ROCKY FLATS SITE REGULATORY CONTACT RECORD

Purpose: Path Forward for Original Landfill (OLF) Seep 7 Drain Extension, Berm Maintenance

Contact Record Approval Date: September 2, 2008

Figure 2. Seep 7 Extension Conceptual Plan

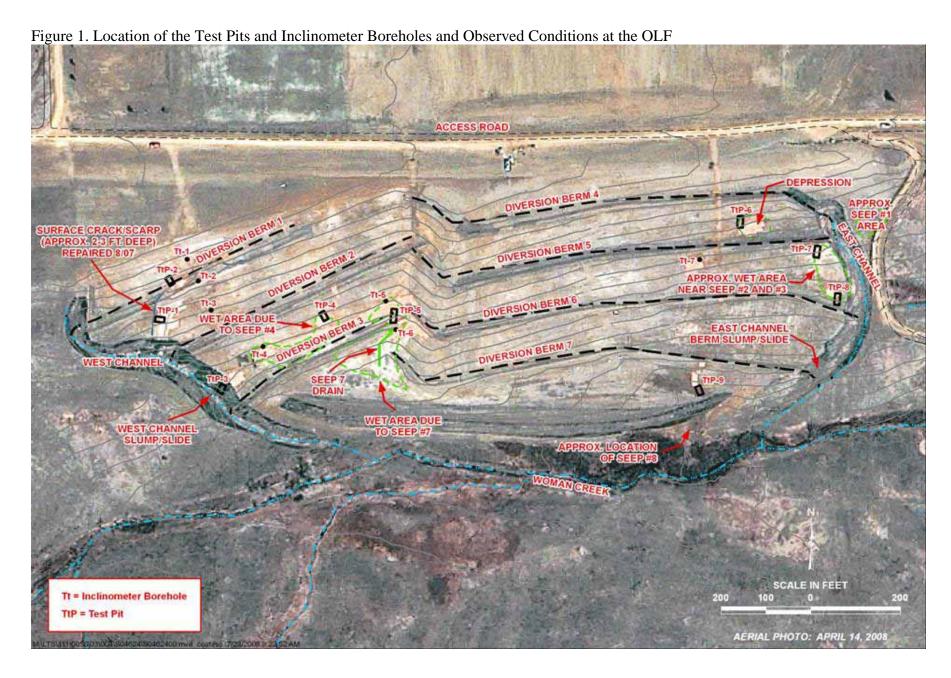
3. Seep 7 drain extension – An extension to the current drain will be installed upgradient within the 2-foot cover depth in the general area where this seep has expressed ("day lighted") on the surface and resulted in saturation of surface soil. This will be carefully constructed in the cover layer so as not to intrude into the underlying soil/waste. At its southern end, the excavation will extend below the cover material for a short distance to a depth of 4 to 5 feet to tie into the existing drain. Figure 2 shows the conceptual design for the drain extension.

The OLF M&M Plan will be modified to document the drain extension, including updating the drawings to show the location.

Resolution: The final design of the Seep 7 drain extension will be submitted to CDPHE for approval. Construction of the Seep 7 drain extension will take place after CDPHE approval.
